ADDENDUM 1

RFP # 25-0045

Southeastern High School CTE Annex—District Technology Infrastructure Additions

ADDENDUM NO2

Appendix B-2

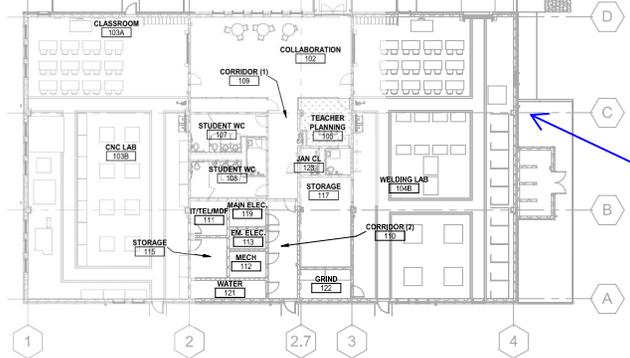
Underground pathway from new IDF to ceiling space in main building, for the purposes of running the fiber link, will be installed by others
